RPA STAFF RECOMMENDATION

Subdivision Case Number:	2016-056	PC Meeting Date: 09-12-16
Subdivision Name:	Briarhaven Subdivision Lots 1 thru 10	
Applicant Request:	Final Plat	
Property Location:	Briafield Lane (Banks @ Standifer Gap)	
Property Owner:	Terry and Martha Wall	
Surveyor/Engineer:	Copp Engineering Group	
Total Acreage:	7.46 Acres	
Proposed Density:	1.34 dwelling units per acre	
Proposed Use:	Single-family detached dwellings	
Number of Lots:	10	
Accessibility:	New 50' right-of-way off of Banks Road	
Tax Map Number:	150-140	
Zoning:	R-1 Residential District	
Subdivision Variances Required:	None	
Staff Recommendation:	<p>APPROVE as a Final Plat subject to the following conditions:</p> <ol style="list-style-type: none"> 1. Installation and completion of all required infrastructure related improvements as part of this subdivision development. 2. Submittal of all required infrastructure “as-builts” to the appropriate departments.

FINAL PLAT

BRIARHAVEN S/D

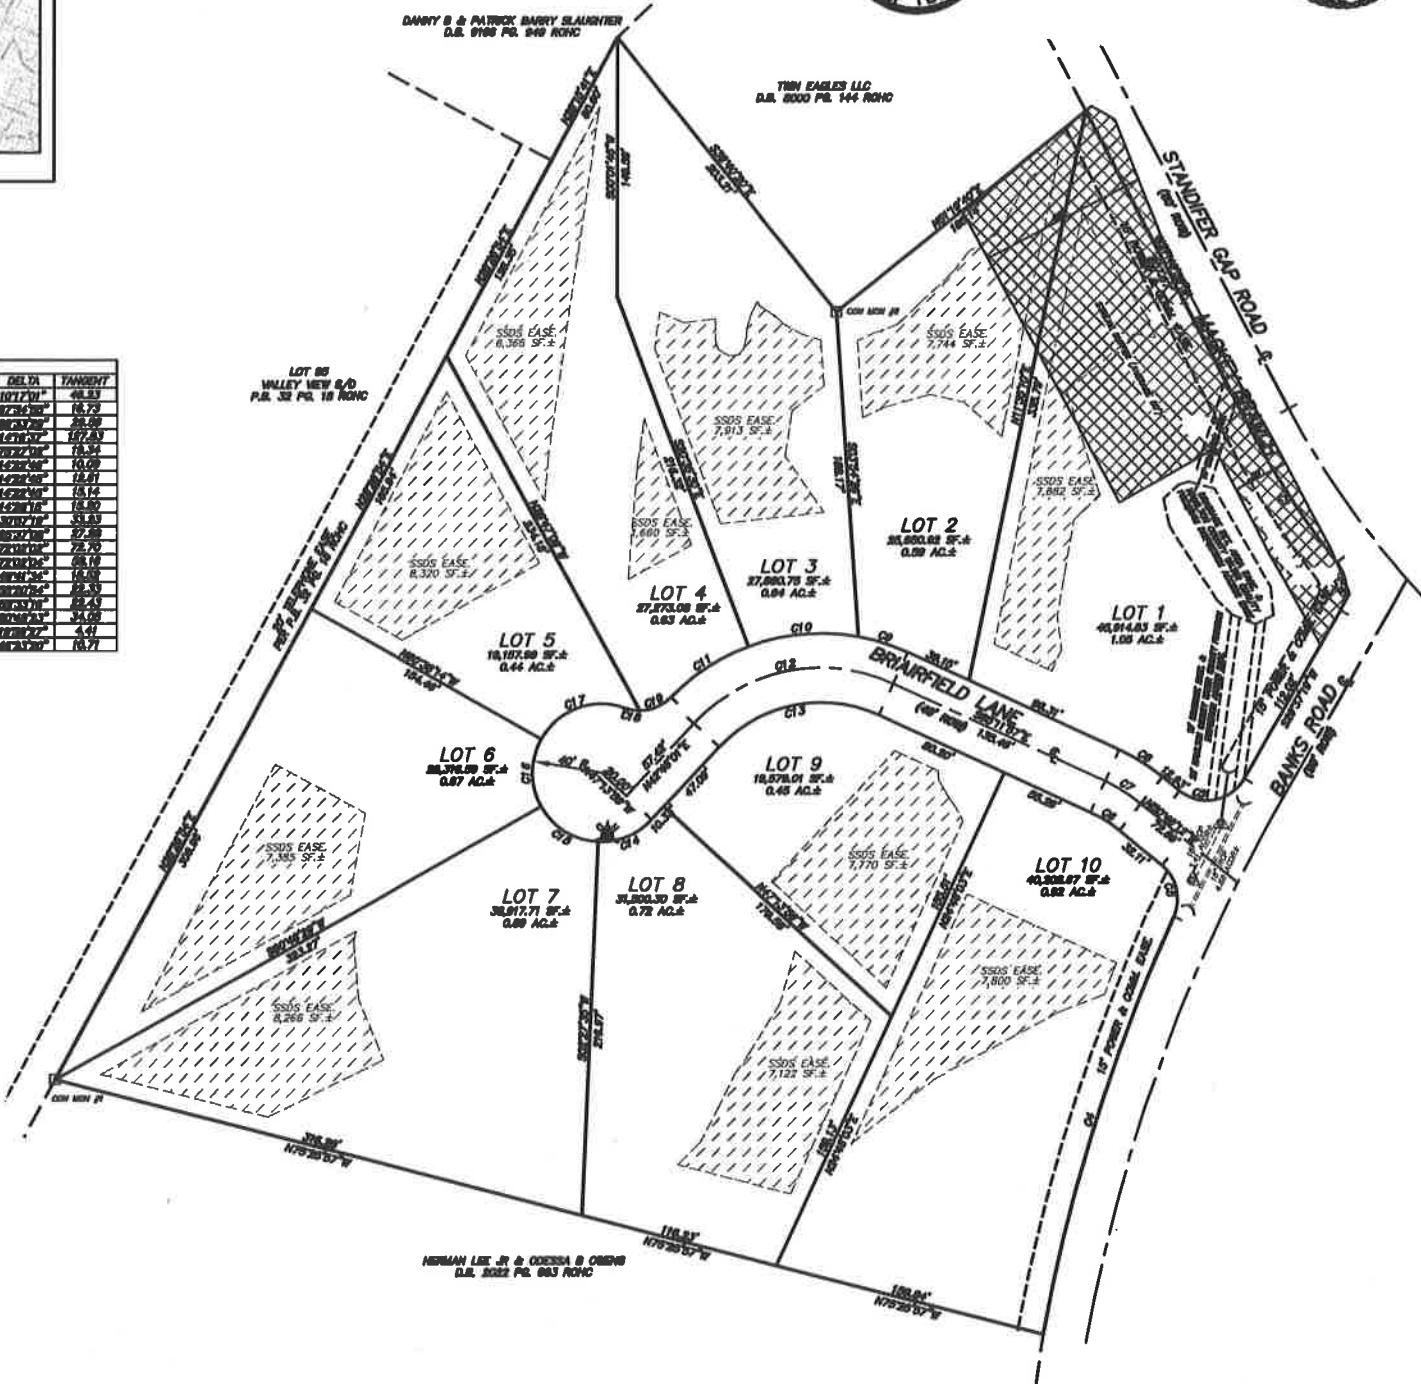
1. Add the following note: “The Preliminary Plat was approved on Feb 8, 2016. See Resolution Number 2016-013”.
2. Contact Hamilton County GIS for street name approval.

1. Sanitary sewers are not available. Submit plans to the Hamilton County Groundwater Protection for review and approval of septic tanks on the property.
2. Questions concerning Hamilton County Groundwater Protection comments and notes contact Hamilton County Groundwater Protection.

1. Add street addresses. Hamilton County GIS will assign street addresses after the Final Plat is approved by the Chattanooga-Hamilton County Regional Planning Commission.
2. Prior to Hamilton County GIS signing the Final Plat please submit the Geo-referenced CAD drawing used to create this subdivision plat. If GIS doesn't receive a copy of the Geo-referenced CAD drawing file GIS will not sign the Final Plat.
3. Questions concerning Hamilton County GIS comments and notes please contact GIS at (423) 209-7760.
